Meeting Date: October 21, 2025 Item Number: 25-13	From: Mike Malyy, Caltrans
Sponsored By: Amjad Obeid, Caltrans	Presented By: Mike Malyy, Caltrans
Description: Request for review and recommendation to finalize CA MUTCD 2026 Part 9 titled "Traffic Control For Bicycle Facilities" proposed documents that have been revised in response to 10/2/25 CTCDC Meeting comments and is being prepared to adopt Federal Highway Administration's National MUTCD 2023 (11th Edition) before the January 18, 2026, deadline.

California Traffic Control Devices Committee Agenda Item Report

11. CTCDC Comment – Chapter 9E, Section 9E.09, Paragraph 05, and Figure 9E-1:

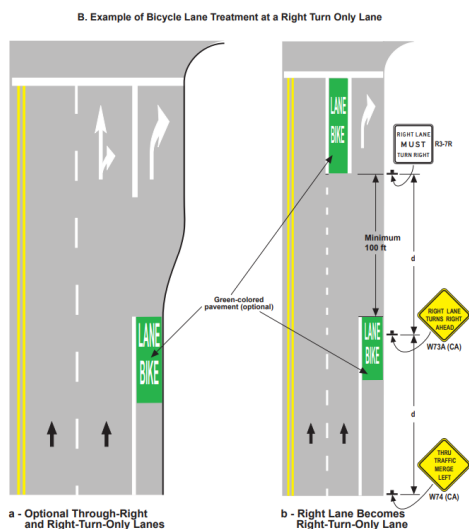
CTCDC member comment: I am concerned that many agencies will continue to use green under sharrows, helmeted bike rider stencil, and green plastic posts on bikeways, even though CAMUTCD now states that we are not allowed to use them. If Caltrans is a member of AASHTO and can work with 49 other states on this, this should provide adequate justification for FHWA.

FHWA comment: The experimental process in the national committee provides an outlet for these concerns to be brought forth and it has been done. The green bikeway under the sharrows has been extensively tested in experiments across the country. The policy and the manual now is the result of that experiment and research. There are 49 other states that do things differently and by law, has to be uniform. There hasn't been lack of discussion on this. The designer cannot vary. I cannot support a variance from the standards in the national manual. Our job is to ensure that the CA manual meets the code of the federal regulations. Caltrans staff has worked hard to do that, but it has not been without discussion and some good points have been raised by the subject matter experts. But the regulation is what it is, and the standard is what it is. The designer who chooses not to go with the standard has to make that choice, has to violate that consciously. Phasing out the helmeted bike symbol will take time. 20 years ago Caltrans agreed at that time that these things will be phased out with the next revision. The next revisions came and went and here we are 20 years later and it is time to conform with the CFR. Unfortunately, there is going to be disagreements and there are thousands of examples in the state on one type of device that are non-compliant. Caltrans has made that conscious choice over and over again to not comply with the manual. That does not make it right. We cannot support deviations from the standards and guidance unless it complies with the CFR. Caltrans can pass a law which make it more restrictive but they cannot pass a law to make it less restrictive than the MUTCD. So, 1) We do not a lot of leeway and 2) Caltrans doesn't have a lot of time on this manual update.

Caltrans acknowledged the comment and explained that FHWA produced the new standard, and justification is needed to deviate from Federal standard.

Figure 9E-4(CA). Example of Bicycle Lane Markings on an Approach to an Intersection that Transitions from a Shared Lane

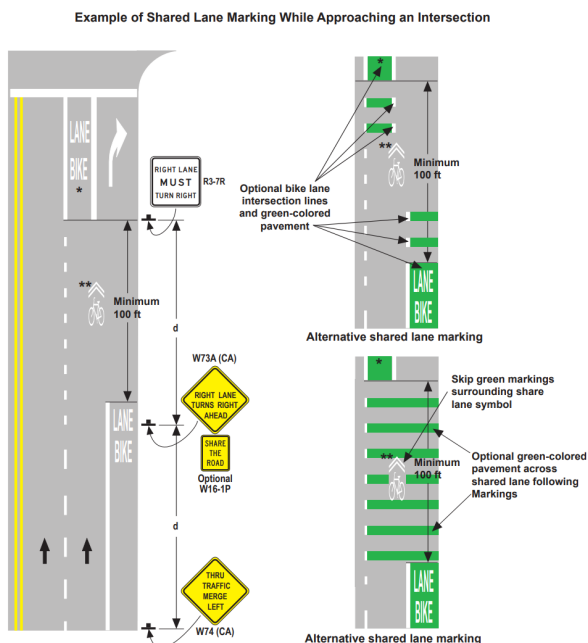
CTCDC member comment: The title is incorrect. Should be: Example of Bicycle Lane Markings on an Approach to an Intersection where the Right Lane Becomes a Right Turn Only Lane.

Also, because it is not directly related to national MUTCD Figure 9E-4, it seems like it should be part of the Figure 9E-3 series.

Caltrans comment: 9E-4(CA) is similar to 9E-3(CA)(Sheet 2) drawing b, but is more focused on the shared lane markings and adds additional details regarding that. Will change 9E-4(CA) to 9E-3(CA)(Sheet 3), and shift the following sheets.

Figure 9E-8(CA). Example of Counter-Flow Bicycle Lanes (Sheet 2 of 2)

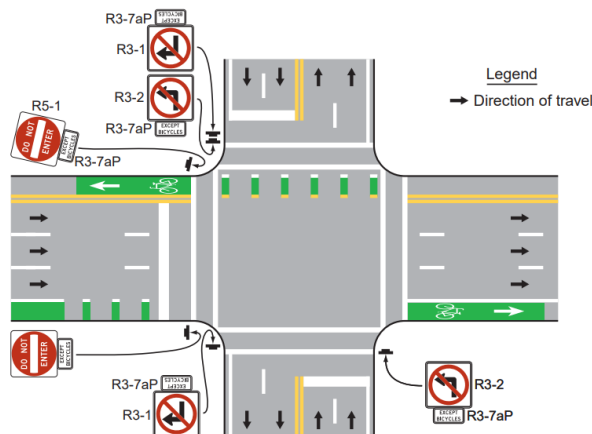
CTCDC member comment: This figure is nearly identical to Figure 9E-8 (the only substantive difference is green paint in the counter-flow bike lane approaching the intersection). Should Figure 9E-8(CA)(Alternatives 1 and 2) replace Figure 9E-8 rather than supplementing it?

Caltrans comment: Whenever we make several changes to a Federal Figure, we create a new supplemental figure(s). We feel there are enough changes to have a new figures.

16. CTCDC Comment – [Figure 9E-106\(CA\):](#)

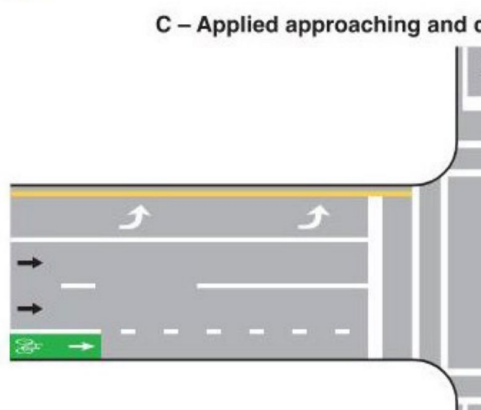
CTCDC member comment: How do these work with Figure 9E-7 Examples of Markings for Separated Bike Lanes (Sheets 1 and 2)? They seem to very closely

cover the same material, and if there is no distinction between Separated Bike Lanes and Separated Bikeways, then why two sets of very similar details?

Both bikeways (CA figures) and bicycle lanes (federal figures) are being used in this case as general terms for dedicated bicycle facilities. CA Figures exist to provide more examples. Can evaluate for redundancy in the future.

Also, the Figure on Page 40 should be titled Figure 9E-105(CA).
